SUBJECT: WORKING COPY OF THE MEETING MINUTES OF THE ACRS
SUBCOMMITTEES ON THERMAL HYDRAULIC PHENOMENA
AND RELIABILITY AND PRA SUBCOMMITTEES, NOVEMBER
5, 2002, ROCKVILLE, MD

**ADVISORY COMMITTEE ON REACTOR SAFEGUARDS
THERMAL HYDRAULIC PHENOMENA
AND
RELIABILITY AND PRA SUBCOMMITTEES
GSI 189- "SUSCEPTIBILITY OF ICE CONDENSER AND
MARK III CONTAINMENTS TO EARLY FAILURE FROM
HYDROGEN COMBUSTION DURING A SEVERE ACCIDENT"
ROOM T-2B3, 11545 ROCKVILLE PIKE, ROCKVILLE, MARYLAND
MEETING MINUTES
November 5, 2002**

Advisory Committee on Reactor Safeguards Subcommittee Meeting on Thermal-Hydraulic Phenomena (GSI-189); Revised

Cost (Impact) Assessment Process: GI-189

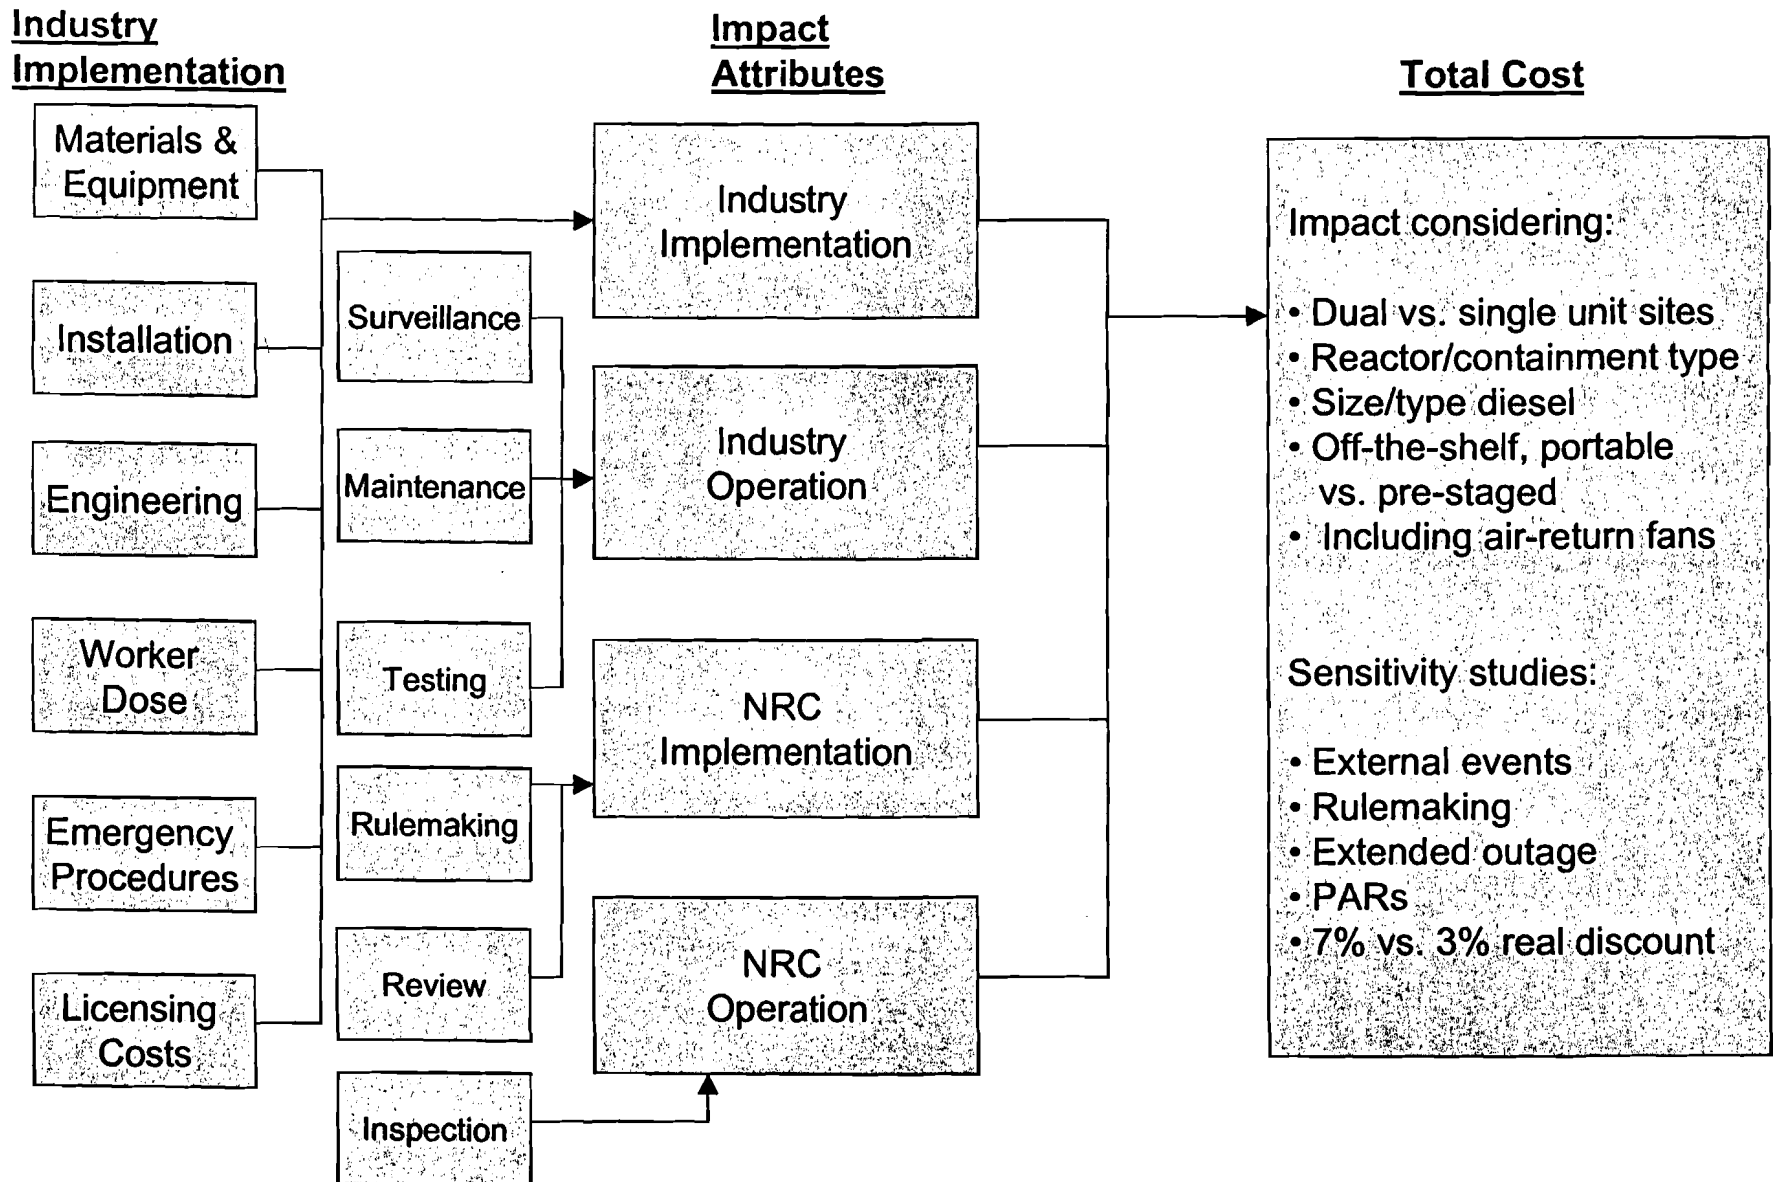
- Dr. Wallis asked why the NUREG-1150 Sequoyah source term was grafted onto a Duke plant. Mr. Lehner explained that the Duke source term was considerably smaller than that used in NUREG-1150 and had a commensurate impact on the averted cost as shown on Slide 10.
